AMENDMENTS TO THE DRAWINGS

REMARKS

FIG.10

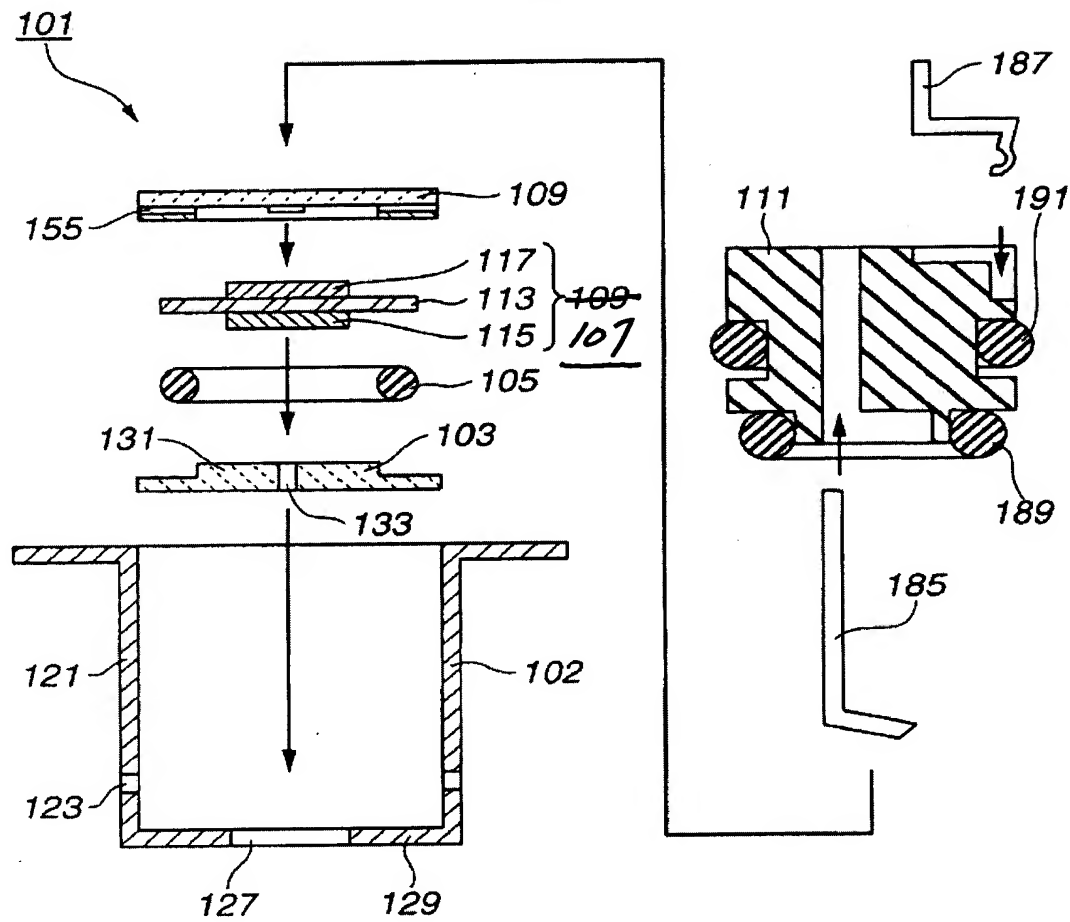
Two (2) replacement drawing sheets (Figs. 10, 11 and 17) are submitted herewith. Fig. 10 has been amended to correctly identify sensor element 107. Fig. 17 has been corrected so as to be designated "PRIOR ART". Fig. 11 is unchanged.

The Examiner has objected to the drawings because of various informalities as outlined on pages 2 and 3 of the instant Office Action. Applicants hereby amend FIGS. 10 and 17 and amend the specification in order to correct the noted deficiencies.
